FIRE STATION CONSTRUCTION AINKAWA, IRAQ

SIGIR PA-06-036
APRIL 12, 2006

SUBJECT: Report on Project Assessment of the Fire Station Construction, Ainkawa,
Iraq (Report Number SIGIR-PA-06-036)

Site Photo 4. Honeycombing/exposed reinforcing steel in concrete column on Level 1 - Photo provided by USACE.

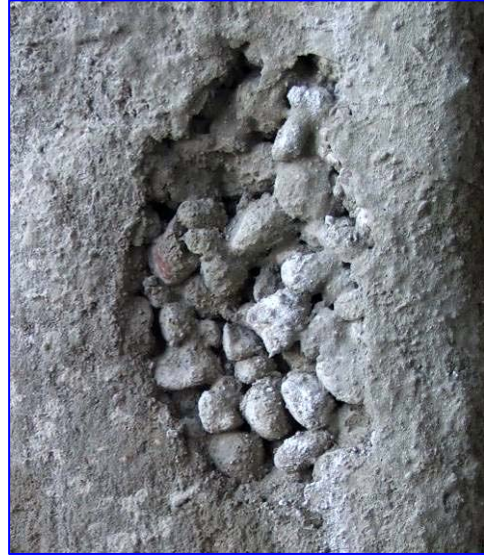
The USACE RE informed us there is a serious issue with the quality and possible structural integrity of the reinforced concrete shear walls, columns and beams located in Level 1. Parsons constructed these structural members in Level 1 in early May 2005. There were considerable voids in the reinforced concrete on this level, particularly in the columns. The first three meters of the columns contain significant honeycombing³ resulting from improper placement and poor vibration of the concrete. The contractor batched the concrete onsite utilizing a small drum mixer (less than 1 cubic meter (m³) in size). The mixer produced one small batch at a time without proper controls in place to assure the same mix ratio was utilized for every batch. The process used by the contractor to fill the forms with concrete was similar to a "fire brigade," where buckets of concrete were passed down a line of workers, up a ladder and poured into the form from the top. By pouring the concrete from the top of the forms, vibrators could not reach the bottom. As a result, the concrete could not be uniformly distributed, especially in the lower areas of the column or wall. Site Photos 4-8 show honeycombing found in columns in Levels 1 and 2 after concrete placement.

Parsons' quality control engineer discovered the honeycombing and reported it in his 10 May 2005 quality control report. Based on a 17 June 2005 letter from

the USACE Administrative Contracting Officer (ACO), Parsons' quality control engineer instructed the subcontractor to repair the concrete defects using an epoxy grout. However, Parsons' home office quality control engineer in Baghdad directed the subcontractor to make the repairs using a rich cement and sand mortar mix. Subsequently, the contractor patched the honeycomb areas utilizing the rich cement and sand mix as illustrated in Site Photo 9. The USACE RE was not satisfied with this method of repair, favoring instead the use of an epoxy grout to fill the voids in the concrete.

In addition to the patching of the honeycomb areas, the ACO also noted in their 17 June 2005 letter that USACE continued to have serious concerns regarding the structural integrity of the work performed. The ACO requested Parsons to certify that full design strength of the elements in question had been achieved. As of 14 February 2006, Parsons had not provided the certification. Parsons did conduct ultra sound testing on 12 and 13 November 2005 to determine the density of the concrete in the walls, columns and beams. Test results were recorded in newtons per square millimeter (N/mm^2), with values ranging from 25.6 to 36.7 N/mm^2 . The testing report also stated:

1. The district has formally directed the contractor to certify that the sheer walls and columns are structurally sound and consistent with the design specifications on two occasions; 17 June 2005 and 4 April 2006. The contractor was asked to respond within 15 days of receipt of the latest letter.

2. This directly relates to Recommendation 1. Mortar patches were made to the walls and columns to correct the defects in the concrete. The district has formally directed the contractor to certify that the sheer walls and columns are structurally sound and consistent with the design specifications on two occasions; 17 June 2005 and 4 April 2006. The contractor was asked to respond within 15 days of receipt of the latest letter.
3. On 27 March 2006 and again on 6 April 2006, GRN requested GRD-PCO (Programs Directorate) determine if the task order requires driveways, sidewalks, and perimeter walls.
